CITY OF LAS VEGAS INTER-OFFICE MEMORANDUM		DATE: June 24, 2021
TO: Land Development Services Department of Building & Safety		FROM: Jennifer Shinn, P.E.  Flood Control, Engr. Associate Department of Public Works
SUBJECT:	Drainage Study for: 8th and Franklin	COPIES TO: TCE
Cross Streets:	SEC of 8 th Street and Franklin Avenue	Kavison Homes
File Number:	F:\Depot\DSMemos\DS5448B.doc	Bart Anderson, P.E., DevCo
Parcel Number:	162-03-604-004	
Zoning Action:	20-0247-TMP1	
FEMA Flood Zone	YES	NO X
Proposed Storm Drain	YES	NO X

ADDENDUM #1 TECHNICAL DRAINAGE STUDY FOR 8th AND FRANKLIN

Re: Addendum #1 to the Technical Drainage Study for 8th and Franklin

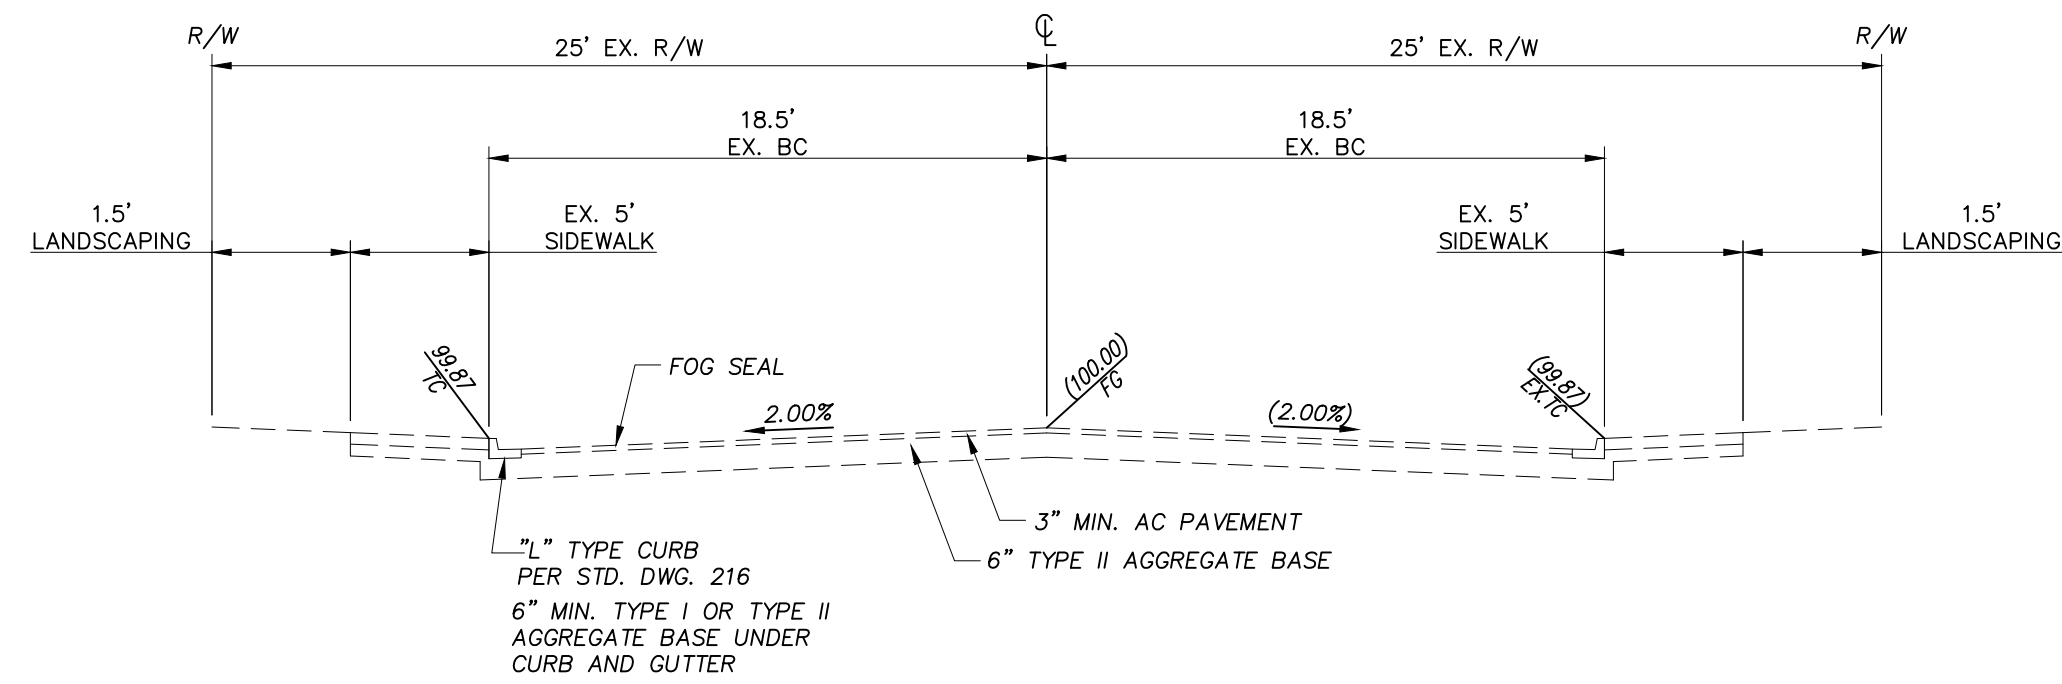
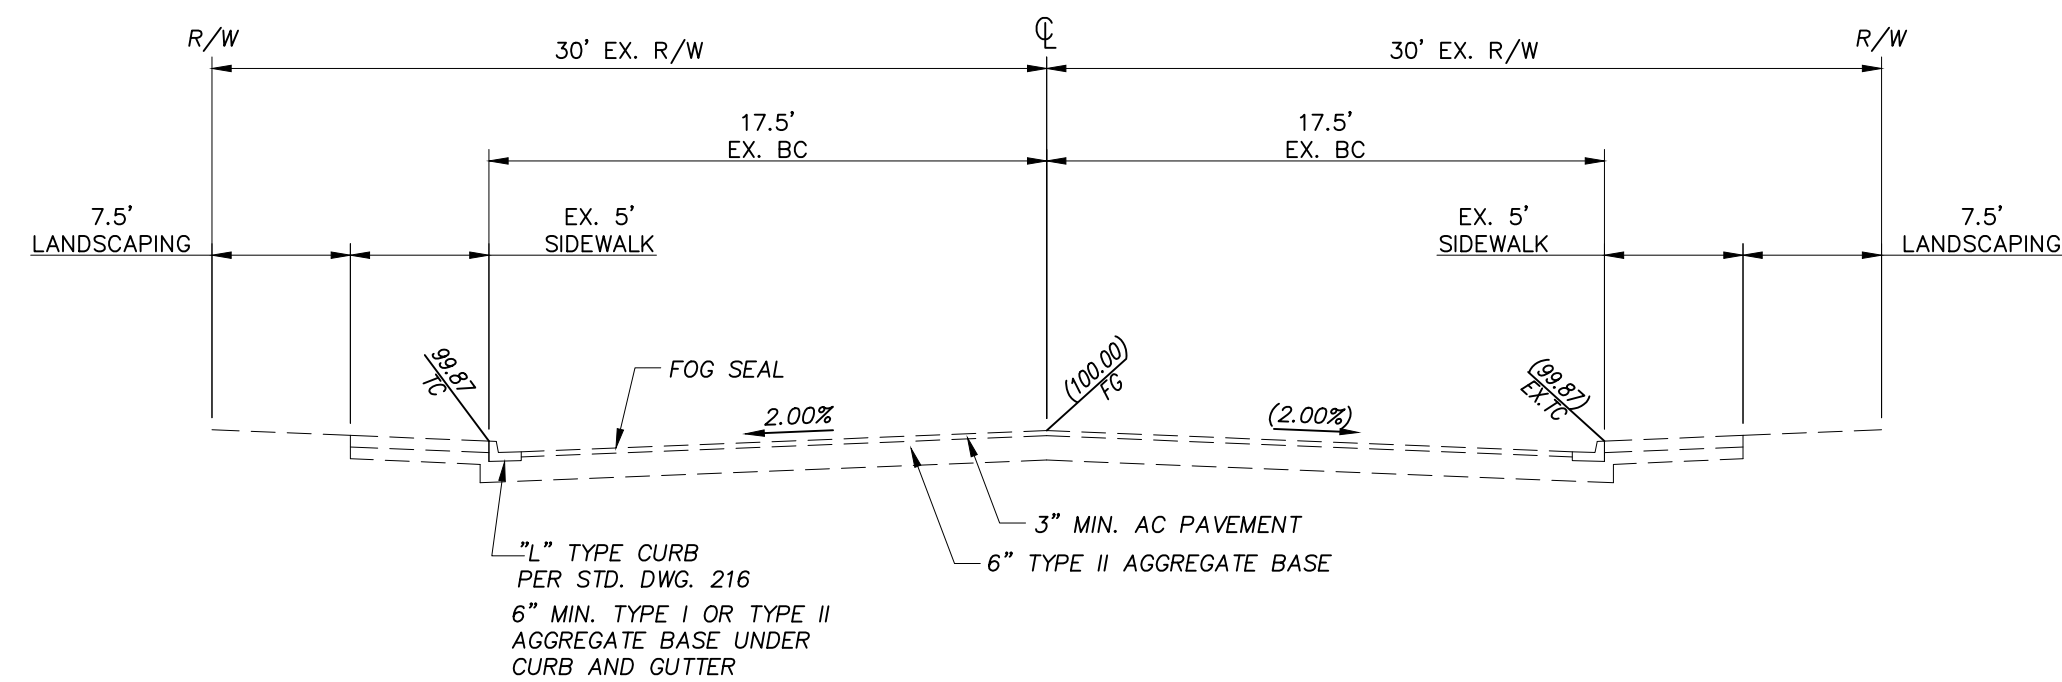
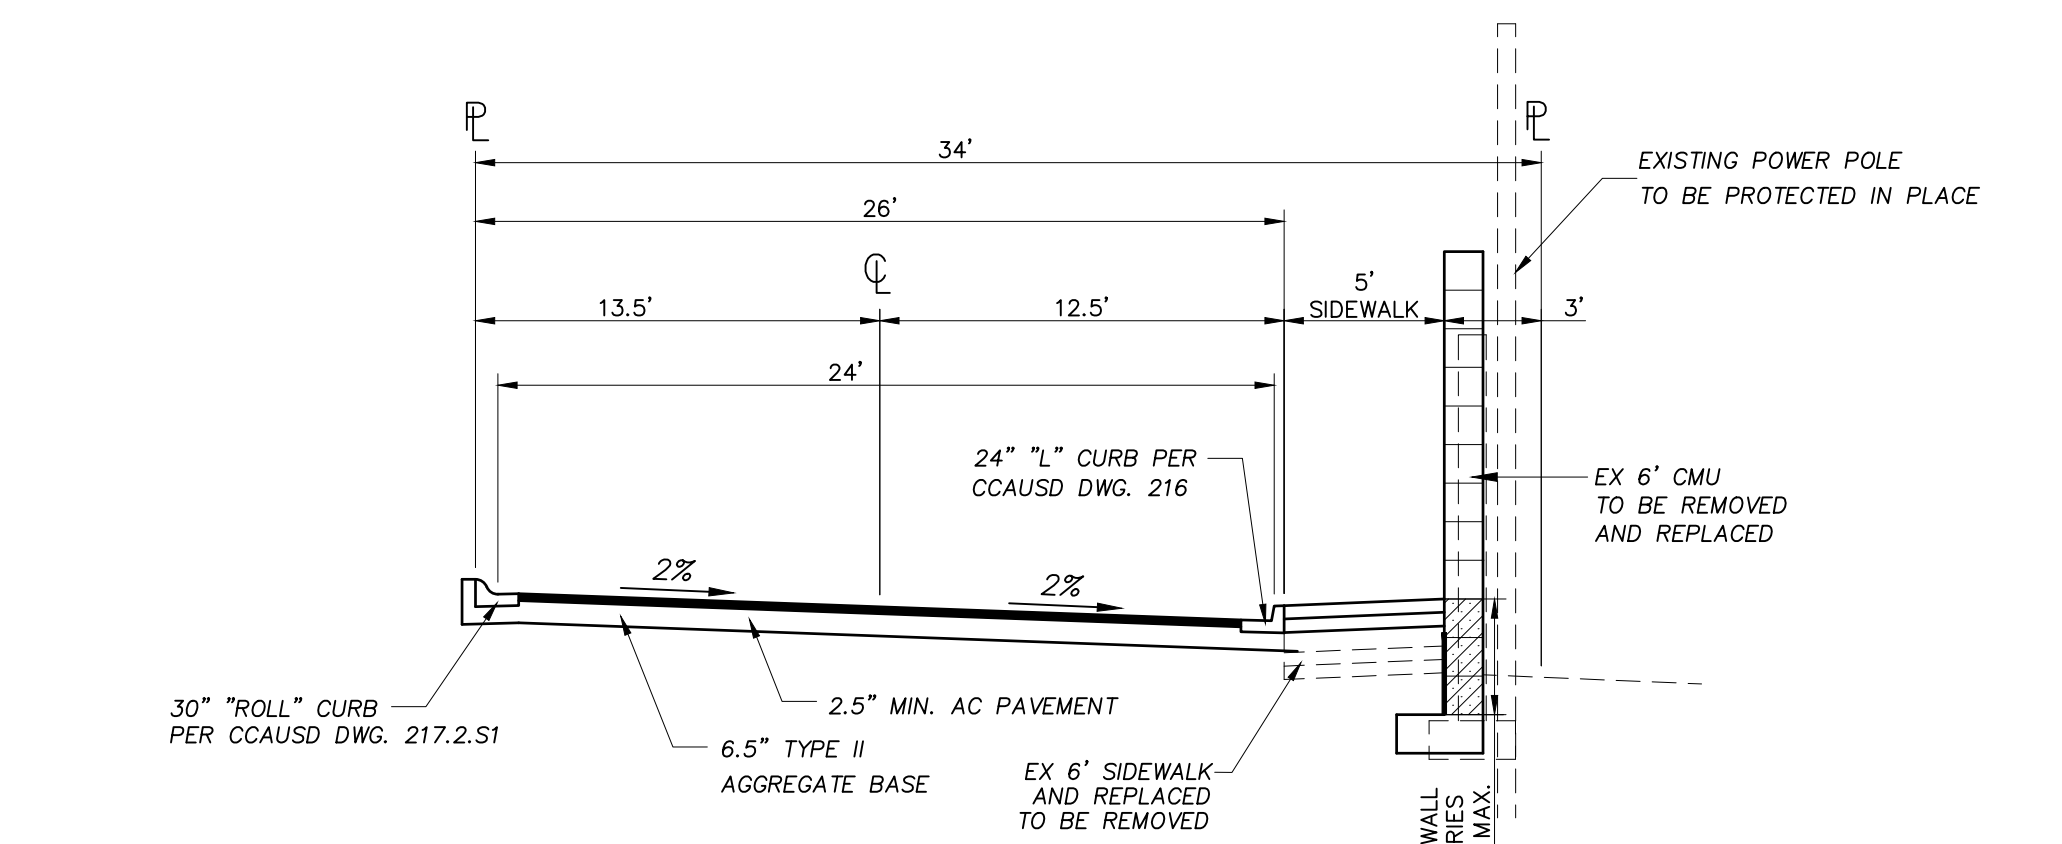
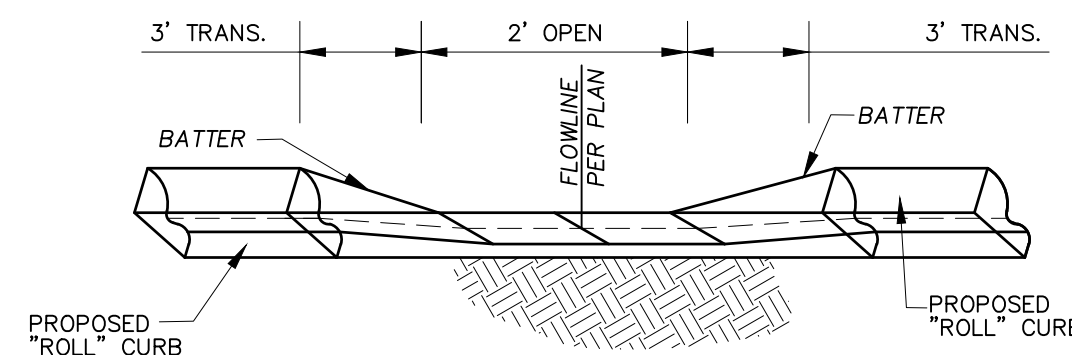
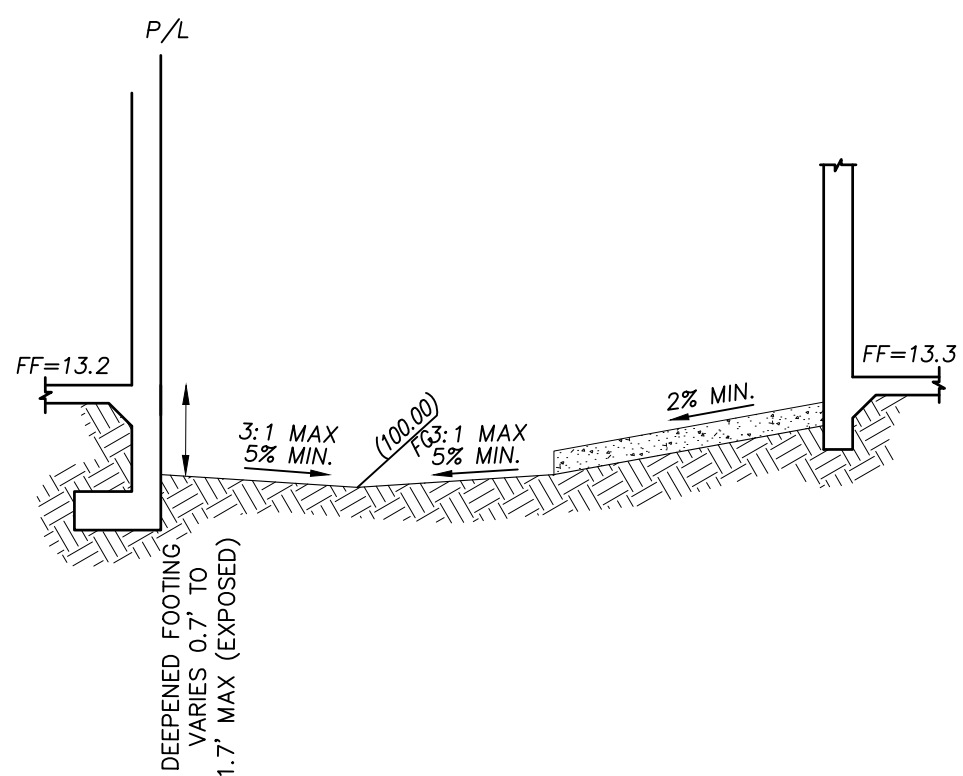
- 1. Unable to complete the drainage study review. The Detail Sheet (hard copy and digital copy) provided is for a different project. Provide the associated Detail Sheet for this project in order to complete the review of the hydraulic cross sections and Grading Plan references to details.**

The correct detail sheet has been included with this submittal.

- 3. The proposed residential project consists of lots with 5'-long driveway leading into the individual garage and finish floor. In comparison to the traditional residential lots, normally with 20'-long driveway leading to the garage, a minimum of 0.5' freeboard from the garage elevation to the adjacent top of curb is provided. In the next submittal, revise the garage elevation (GFF) at all lots such that a minimum of 0.5' freeboard is provided with relation to the adjacent high side TC.**

The alley way is designed with a 2% cross fall and has a depth of flow of 0.39ft. With the cross fall alley, the GFF's are set at least twice the depth of flow above the easterly curb flowline and are adequately flood protected.
